Service Bulletin No: 53-019

ATA Chapter: 53

FUSELAGE - MAIN FRAMES**DO A CHECK OF THE MATERIAL SPECIFICATION OF THE FRAME 11 FITTINGS AND, IF NECESSARY, DO A CHECK FOR CRACKS****1. Planning Information****A. Effectivity**

Removal / Installation of the Elevator-Rear Control-Rod
Figure 1

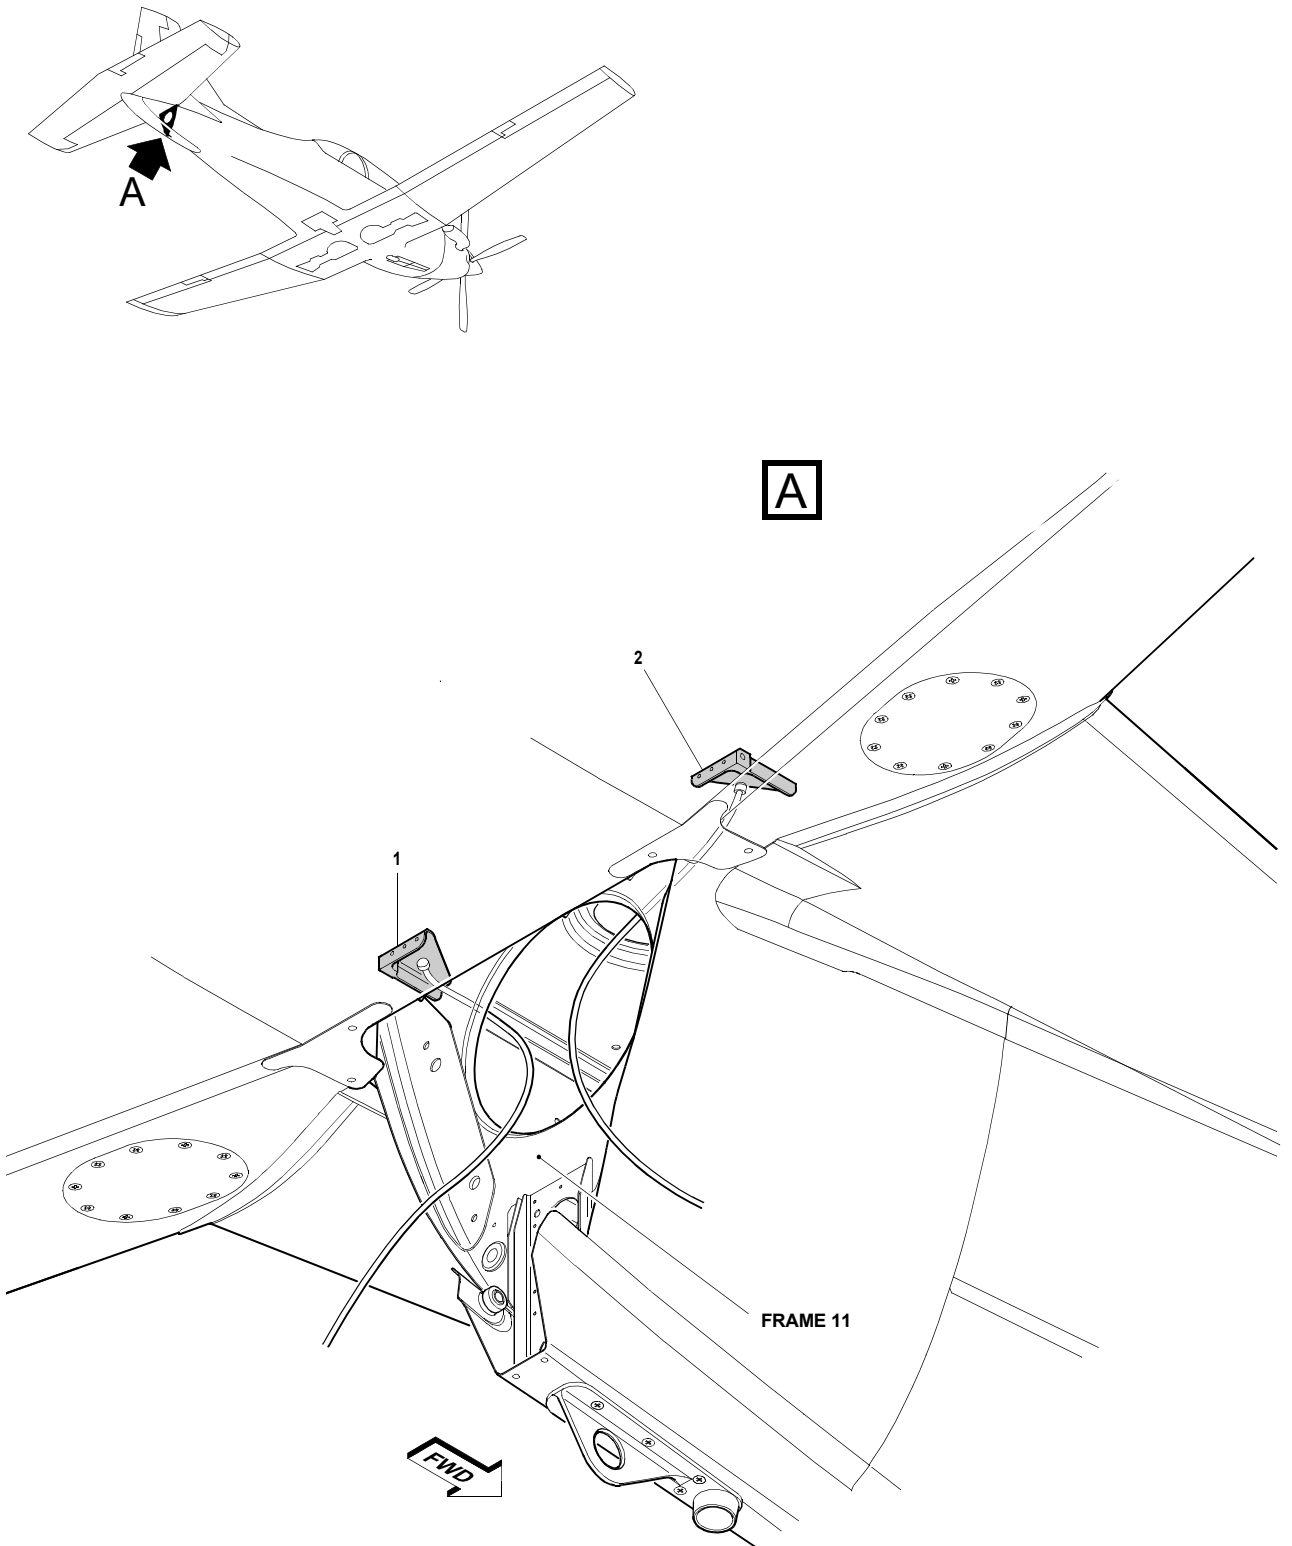
- (3) For better access, you can remove the elevator rear control-rod as follows (Ref. Fig. 1):
 - (a) Remove the nut (1), the washer (2), the bonding strap (3) and the screw (5). Discard the nut (1).

- (b) Disconnect the bonding strap (3) from the loop clamp (4).
 - (c) Move the bonding strap (3) clear of the elevator rear control-rod (9).
 - (d) Remove the nut (7), the washers (8) and (10) and the bolt (11). Discard the nut (7).

- (e) Move the elevator-rear control-rod (9) clear of the rear lever assembly (6).
 - (f) Remove the nut (15), the washer (14) and bolt (13). Discard the nut (15).

- (g) Move the elevator-rear control-rod (9) clear of the lever assembly (12).
 - (h) Remove the elevator-rear control-rod (9) from the aircraft.
 - (i) Use the absorbent paper (Material No. P02-031 made moist with the solvent (Material No. P01-010 to clean:

- (3) If necessary, install the elevator rear control-rod as follows (Ref. Fig. 1):
 - (a) Put the elevator rear control-rod (9) in position between the lever assemblies (6) and (12).

- (b) Apply a layer of corrosion preventative (Material No. P04-039) to the shaft of the bolts (11) and (13).
 - (c) Install the bolt (13), the washer (14) and the new nut (15) (P/N 938.07.68.305).

- (d) Install the bolt (11), the washers (10) and (8) and the new nut (7) (P/N 938.07.68.305).
 - (e) Put the screw (5) through the loop clamp (4).
 - (f) Put the bonding strap (3) and the washer (2) on the screw (5). Install the new nut (1) (P/N 938.07.68.303).

Check of the Material Specification
Figure 2

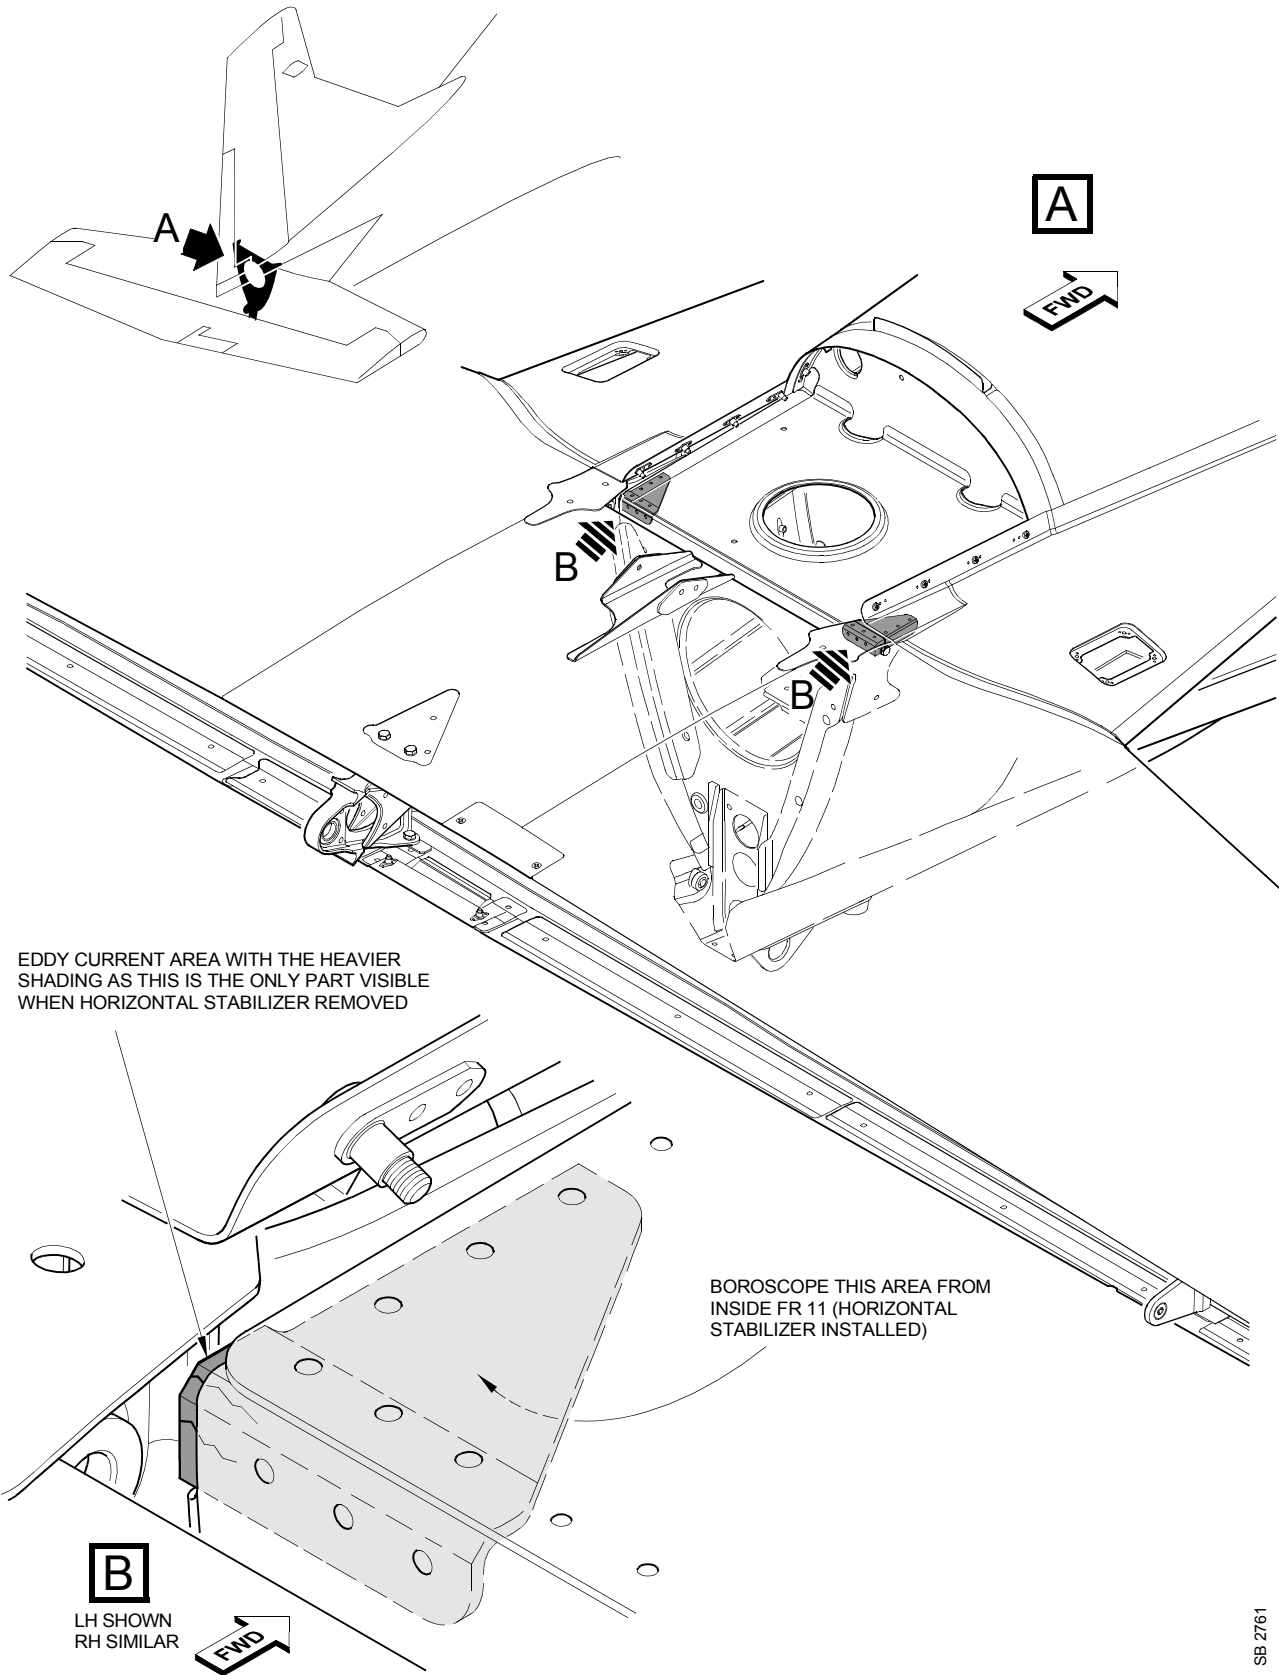
B. Do the Test to Find the Material Specification (Ref. Fig. 2)

(b) Put the eddy current probe in position on the left fitting (1) (P/N 112.35.07.489).

NOTE: Do this through the hole on FR11. Use a torch and mirror to make sure the eddy current probe is in the correct position.

(d) Compare the value recorded above with the values recorded in Step 3.A.(6) and determine if the fitting is manufactured from AA2024-T351 or AA2124-T851.

Fittings - Crack Inspection (If Necessary)
Figure 3

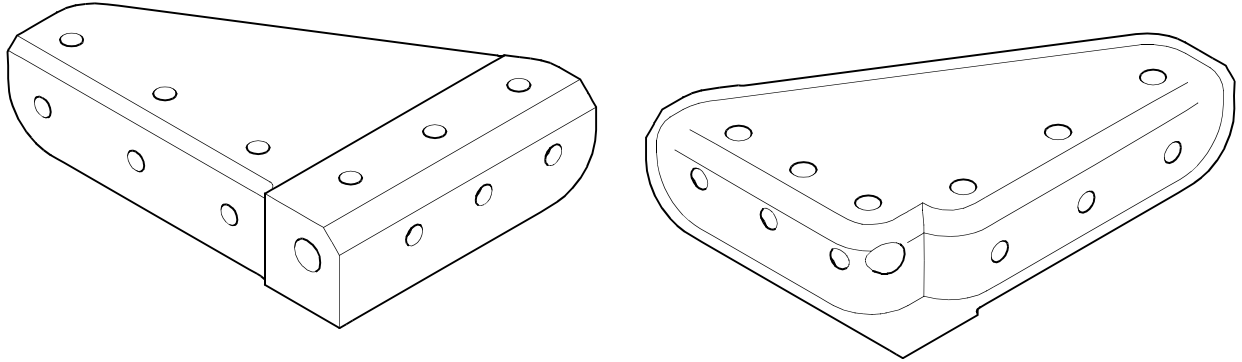
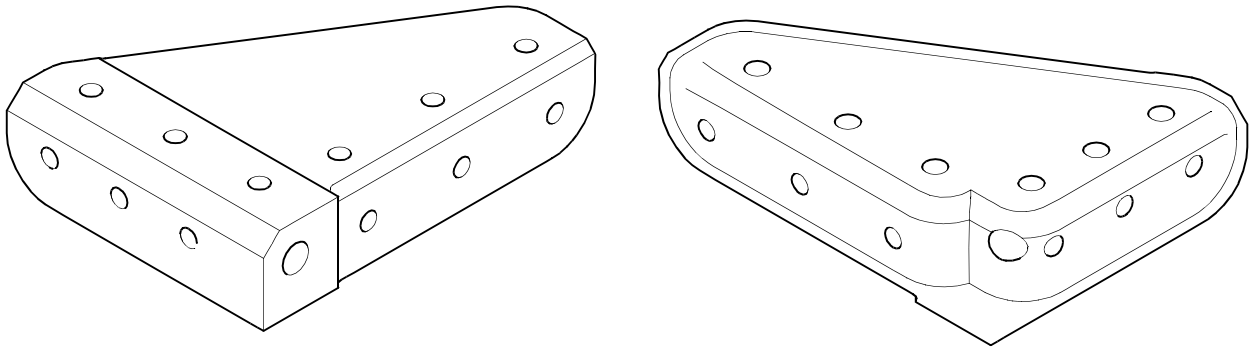
C. Do an Inspection to Find Cracks with the Borescope and / or Eddy Current (Ref. Fig. 3)

(1) Obey the manufacturer's instructions and use a borescope to examine the fitting from inside FR11 (looking AFT) for cracks (Ref. Fig. 3).

NOTE: Make sure you examine all the visible faces of the fittings.

- (2) If you find cracks, you must replace the fitting before the next flight (Ref. Service Bulletin 53-020). Make a copy of the Inspection Report Form (Ref. Fig. 4).
- (3) If you do not find cracks in the area examined in Step 3.C.(1):
 - (a) Remove the horizontal stabilizer (Ref. AMM, 55-10-00, Page Block 401).
